## HISTORIC AND DESIGN REVIEW COMMISSION

**HDRC CASE NO:** 2019-666  
**ADDRESS:** 507 N MONUMENTAL  
**LEGAL DESCRIPTION:** NCB 1370 BLK 2 LOT 37 S 30 FT OF 36  
**ZONING:** C-3, H  
**CITY COUNCIL DIST.:** 2  
**DISTRICT:** Dignowity Hill Historic District  
**APPLICANT:** Steve Santos  
**OWNER:** Linda Maldonado  
**TYPE OF WORK:** Side yard fence  
**APPLICATION RECEIVED:** November 01, 2019  
**60-DAY REVIEW:** December 31, 2019  
**CASE MANAGER:** Huy Pham  
**REQUEST:**

The applicant is requesting a Certificate of Appropriateness for approval to construct a 5 foot tall side yard fence, featuring wood posts topped with 2 foot tall corrugated metal panels.

# PLOT PLAN FOR BUILDING PERMITS

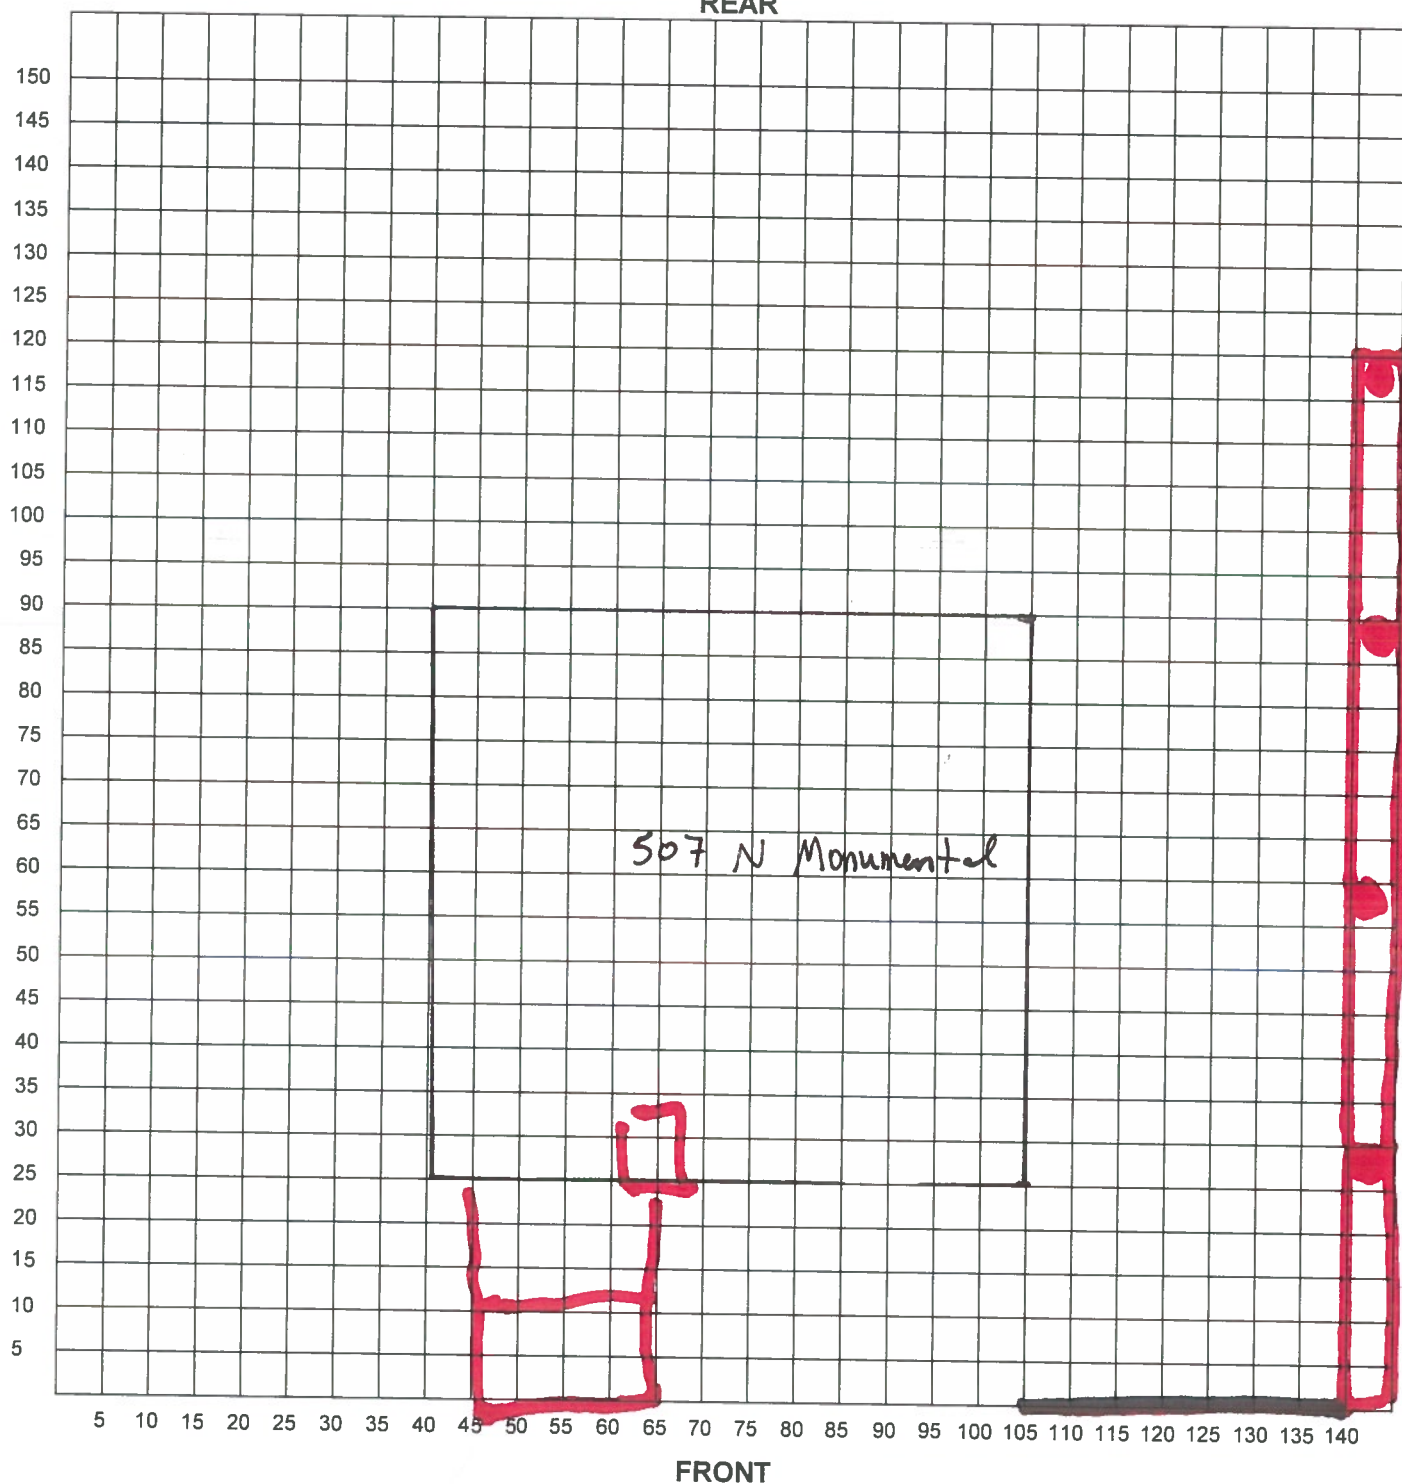
- c. FENCE – The applicant is requesting a Certificate of Appropriateness for approval to construct a 5 foot tall side yard fence, featuring wood posts topped with 2 foot tall corrugated metal panels. The proposed fence spans 50 feet long between 507 and 509 N Monumental.

- d. FENCE DESIGN - The applicant has proposed to construct a 5 foot tall, side yard fence, featuring wood posts topped with 2 foot tall corrugated metal panels. Per the Guidelines for Site Elements 2.B.i, new fences and walls should appear similar to those used historically within the district in terms of their scale, transparency, and character; the design of fence should respond to the design and materials of the house or main structure. Staff finds that the fence design is a departure from any typical fence style in the district. A simple wood privacy fence would be eligible for administrative approval with standard stipulations for height.

- e. FENCE HEIGHT – The applicant has proposed to construct a 5 foot tall side yard fence, featuring wood posts topped with 2 foot tall corrugated metal panels. Per the Guidelines for Site Elements 2.B.iii, applicants should limit the height of new fences and walls within the front yard to a maximum of four feet; the appropriateness of a front yard fence is dependent on conditions within a specific historic district. Staff finds that an open fence should be reduced to 4 foot tall and a solid fence reduced to 3 foot tall past front yard plane.

- f. FENCE MATERIAL - The applicant has proposed to construct a 5 foot tall side yard fence, featuring wood posts topped with 2 foot tall corrugated metal panels. Per the Guidelines for Site Elements 2.B.v., applicants should construct new fences or walls of materials similar to fence materials historically used in the district; applicants should select materials that are similar in scale, texture, color, and form as those historically used in the district, and that are compatible with the main structure. For screening incompatible uses, alternative fence heights and materials may be appropriate where residential properties are adjacent to commercial or other potentially incompatible uses. While the property is surrounded by commercial properties to the south and east and a non-historic infill property to the north, staff finds a simple wood privacy fence would address the privacy concern of the applicant while relating to existing historic patterns.

Staff does not recommend approval of the fence as proposed based on finding b through f. A simple wood privacy fence would be eligible for administrative approval with standard stipulations for height.
